# ControlLogix DeviceNet Interface Module

Catalog Numbers 1756-DNB, Series C and D

## About This Publication

Publication 1756-RN660C-EN-P - February 2011

**Table 2 - Corrected Anomalies in Firmware Revision 11.005**

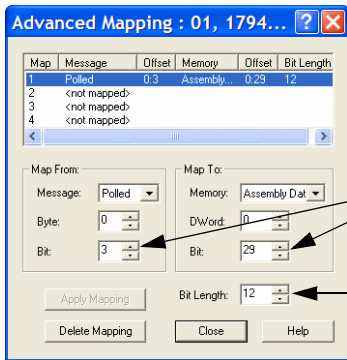
Corrected Anomaly	Description
Connection Failed error type resulted from bridging over DeviceNet via a 1756-DNB module and monitoring device parameters	<p><b>CORRECTED:</b> If you bridged to a device on a DeviceNet network via a 1756-DNB module using firmware revision 11.002 or 11.003 and attempted to monitor the device's parameters in RSNetWorx for DeviceNet software the connection failed and device monitoring stopped.</p> <p>Typically this anomaly occurred 5...10 seconds after device monitoring began. When the anomaly occurred, a connection failed type error appeared in the RSNetWorx for DeviceNet software error window.</p> <p style="text-align: right;">Lgx00107704</p>
